ADDENDUM # 2

RFP # 7548883

**TITLE: ELECTRICAL DISTRIBUTION SYSTEM UPGRADE AND NEW
SUBSTATION – UNIVERSITY OF RHODE ISLAND**

Date Friday, August 15, 2014
Project URI Distribution Substations Upgrade Project

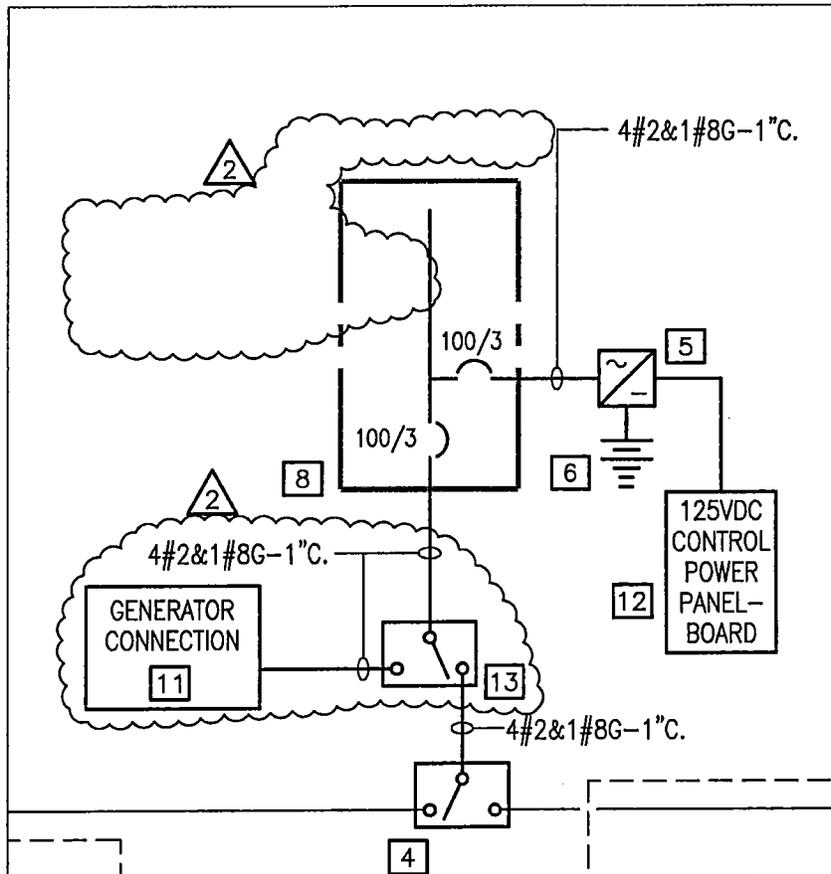
Item #	Drawing#	Title/Description
S03	E6.14	Revise as per SKE-001
S04	E6.16	Revise as per SKE-002

• Please clarify the proposed generator connection voltage at the switchgear, and the need for an additional transfer switch. The scenario shown on will back feed one of the CPT's in the gear.

- 8 150A, 208Y/120V, 10KAIC, 100A MCB WITH INTEGRAL TVSS, 42 POLE, FILL PANEL WITH 20/1 CIRCUIT BREAKERS.
- 9 PROVIDE SIGN UNDER METERS ON MCB'S WHICH READS "VOLTAGE SENSING IS VIA MAIN BUS"
- 10 PROVIDE WARNING PLACARD. SEE NOTE 2,f,v,1 IN 'SEQUENCE OF OPERATION FOR SWITCHGEAR 1 & 2' ON THIS DRAWING
- 11 GENERATOR CONNECTION CABINET. SEE DRAWING E2.11 FOR ADDITIONAL INFORMATION.
- 12 PROVIDE ALL CONDUIT AND WIRE AS REQUIRED BY THE SWITCHGEAR MANUFACTURER TO PROVIDE CONTROL POWER TO THE SWITCHGEAR.
- 13 150A, 3φ, 4 POLE MANUAL TRANSFER SWITCH

Response: Provide two Manual Transfer Switches (MTS) as indicated in sketches SKE-001 and SKE-002

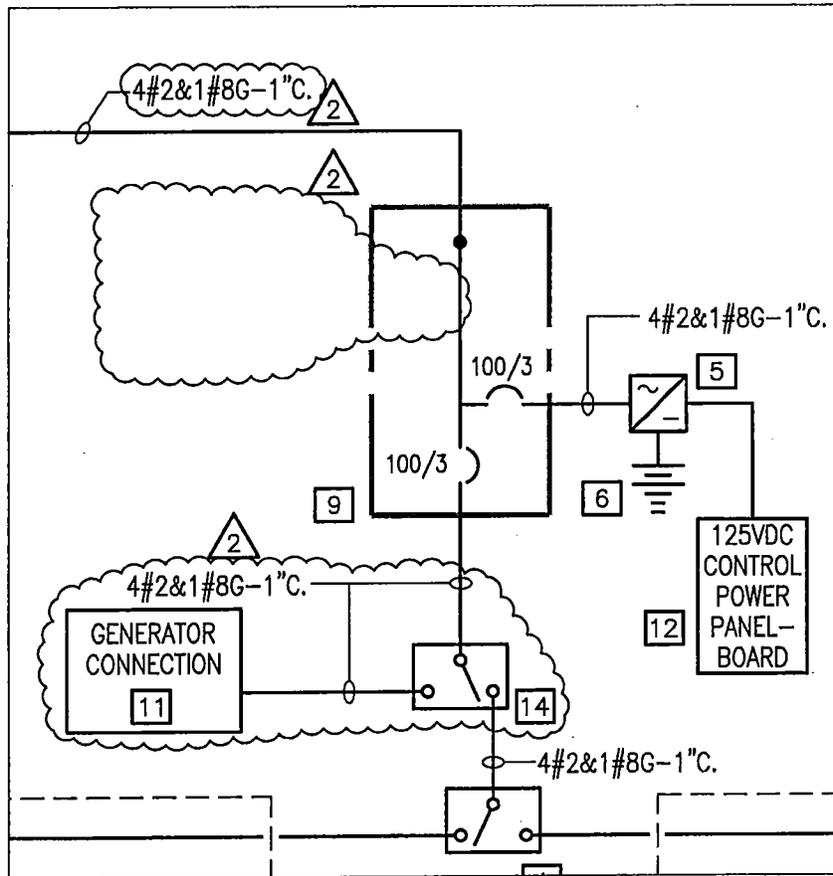
- 9 150A, 208Y/120V, 10KAIC, 100A MCB WITH INTEGRAL TVSS, 42 POLE. FILL PANEL WITH 20/1 CIRCUIT BREAKERS.
- 10 PROVIDE WARNING PLACARD. SEE NOTE 2,f,v,1 IN 'SEQUENCE OF OPERATION FOR SWITCHGEAR 1 & 2' ON THIS DRAWING
- 11 GENERATOR CONNECTION CABINET. SEE DRAWING E2.11 FOR ADDITIONAL INFORMATION.
- 12 PROVIDE SYNCH CHECK RELAY WITH DEAD BUS/LIVE LINE SELECTOR SWITCH EQUAL TO BASLER ELECTRIC BE1-25
- 13 PROVIDE ALL CONDUIT AND WIRE AS REQUIRED BY THE SWITCHGEAR MANUFACTURER TO PROVIDE CONTROL POWER TO THE SWITCHGEAR.
- 14 150A, 3 ϕ , 4 POLE MANUAL TRANSFER SWITCH
